## Application for Licence Amendment

<b>Licence Number</b>	L5107/1988/13
<b>Licence Holder</b>	Northern Star (HBJ) Pty Ltd
<b>ACN</b>	127 026 519
<b>File Number</b>	2012/006867-2~7
<b>Premises</b>	South Kalgoorlie Operations – Jubilee Gold Mine  Legal description –  Lot 15 on Plan 58833, Lot 50 on Plan 226299 and Lot 51 on Plan 226303, Feysville, Lot 103 on Plan 40395 Lot 105 on Plan 40396, Karamindie, and mining tenements M26/118, M26/143, M26/204 and M15/456  As defined by the premises maps attached to the Revised Licence
<b>Date of Report</b>	8 May 2024
<b>Decision</b>	Revised licence granted

**Figure 1 Location of Pernatty open pit and proposed dewatering pipeline**

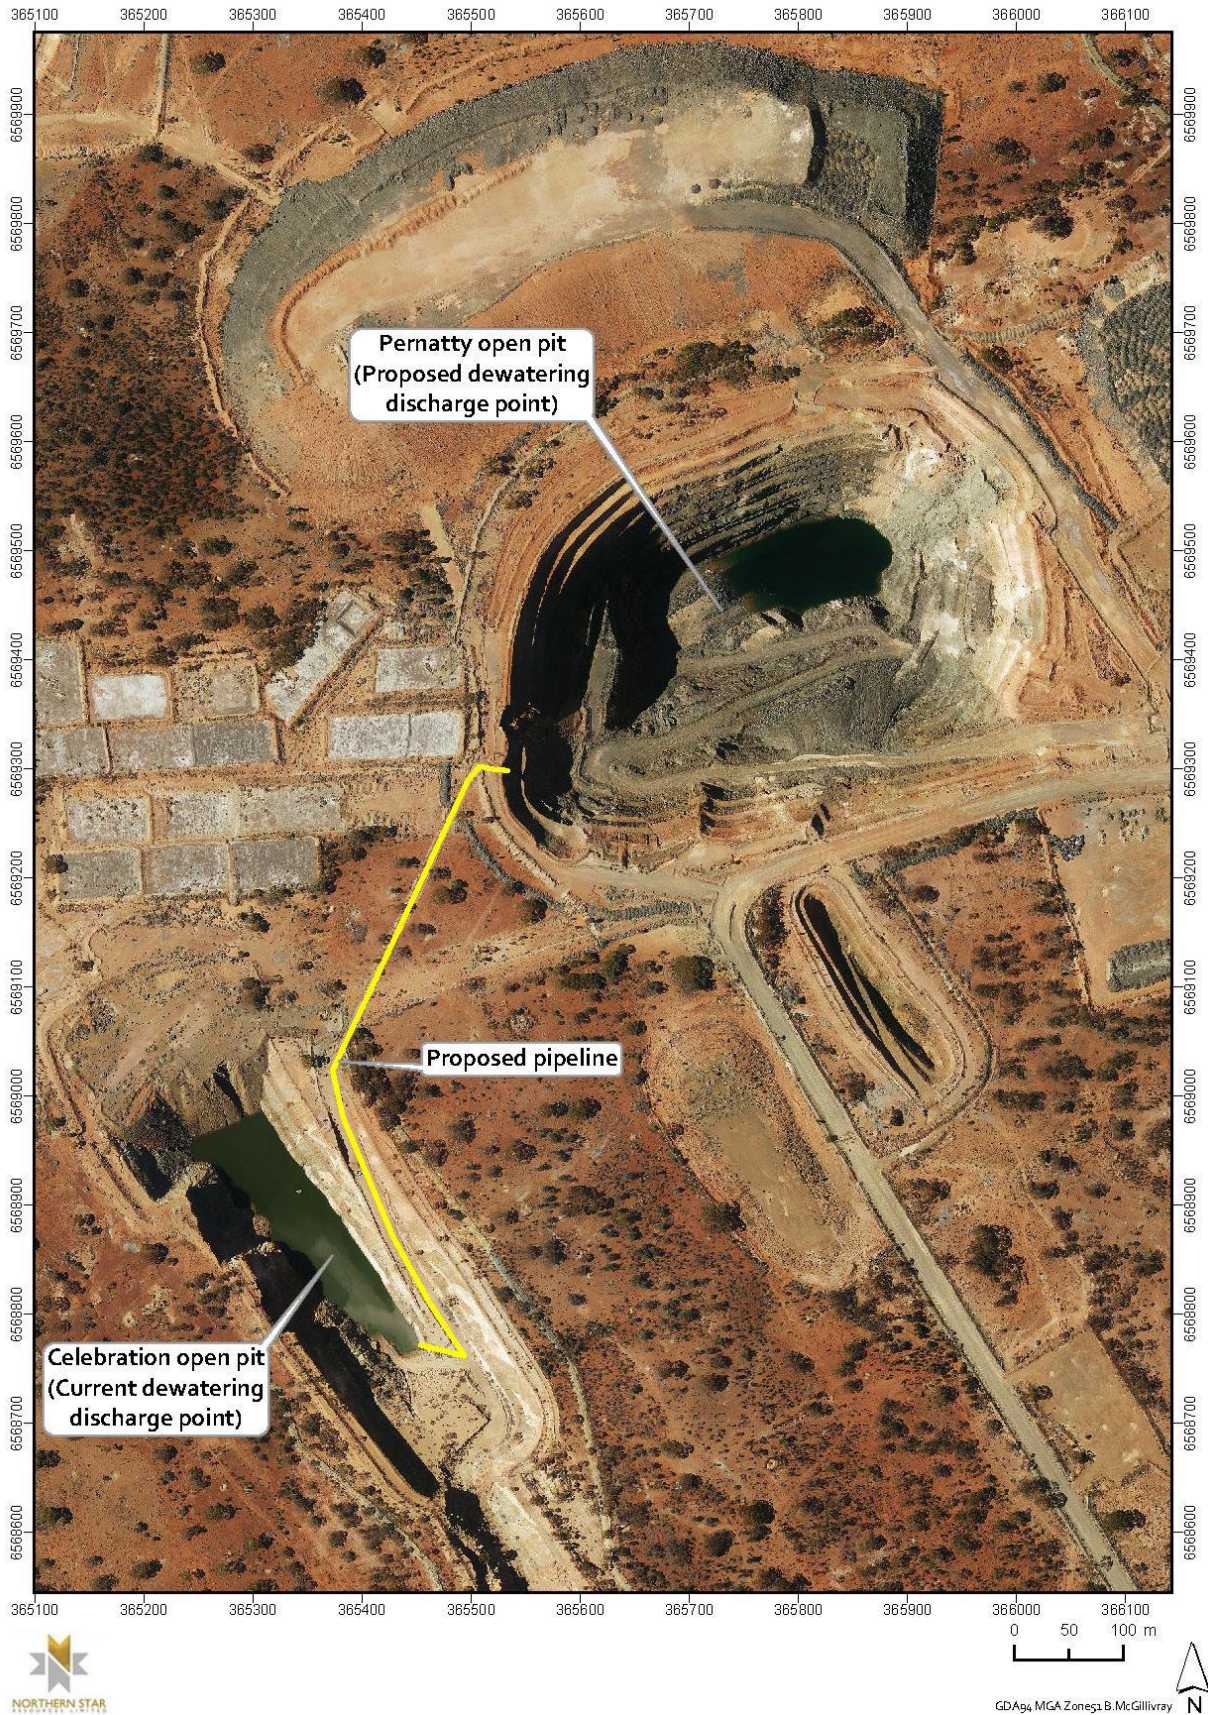
Pernatty open pit is located approximately 310 meters from the Celebration open pit, (crest to crest; Figure 1).

There are existing pipelines from HBJ to Celebration open pit and a new pipeline will be installed between Celebration and Pernatty pits. The new pipeline is expected to be ~650 meters in length. The planned pipeline route is provided in Figure 1 and the installation will be undertaken as per the requirements of the licence.

The Licence Holder provided calculations of the total available capacity of Pernatty open pit to the 4-meters below crest level limit as 7,527,787 m<sup>3</sup>. There is sufficient capacity in Pernatty open pit to receive dewatering from the HBJ mine on a continuous basis and from Celebration pit in the event it requires dewatering. Freeboard survey measurements will be undertaken as per existing licence conditions.

Figure 2 Site layout; dewatering and landfill location

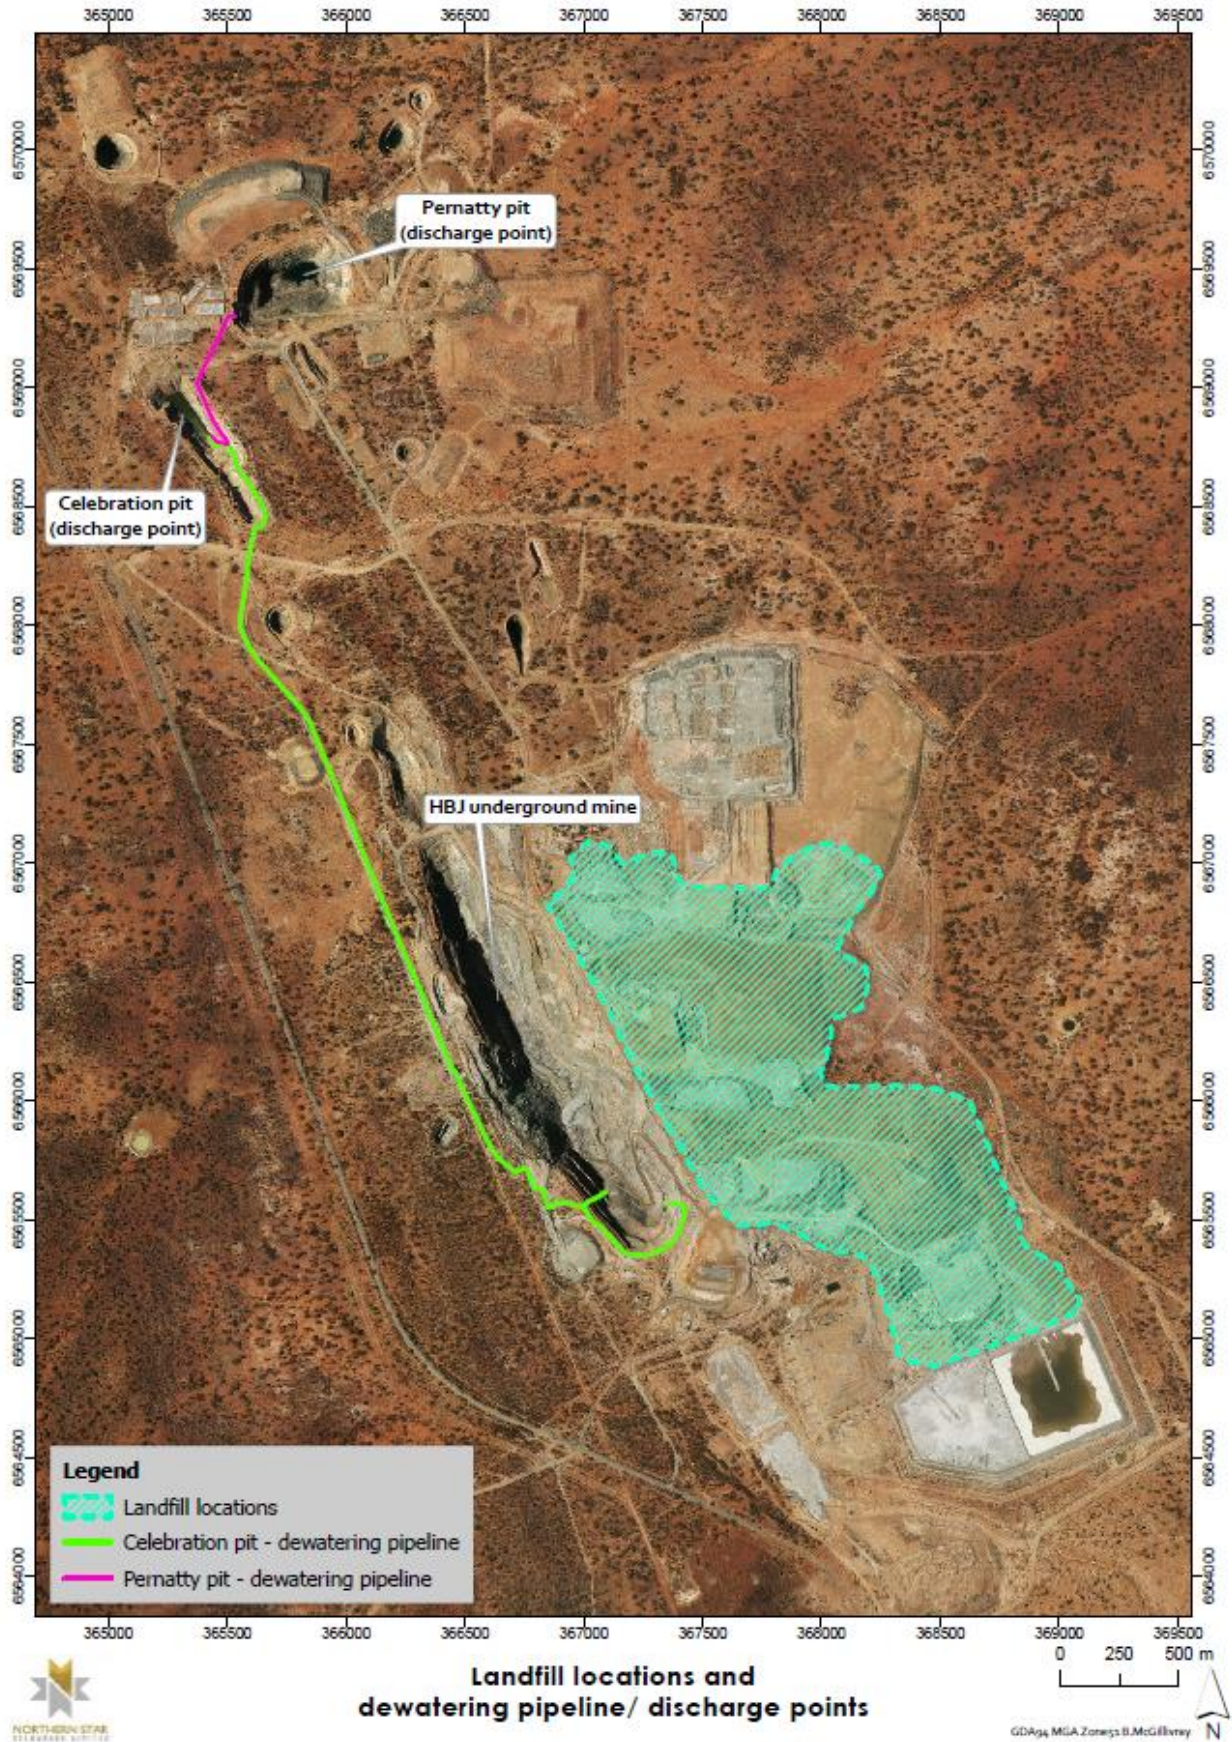
The Licence Holder is proposing to extend the current area of the waste rock dump (WRD) that can be used for landfill purposes (see Figure 2). Extending the landfill area will provide access to create a landfill in a semi-enclosed section of the waste dump which will reduce the likelihood of windblown waste. All landfills constructed at SKO are managed as per Conditions 10 - 14 of the licence.
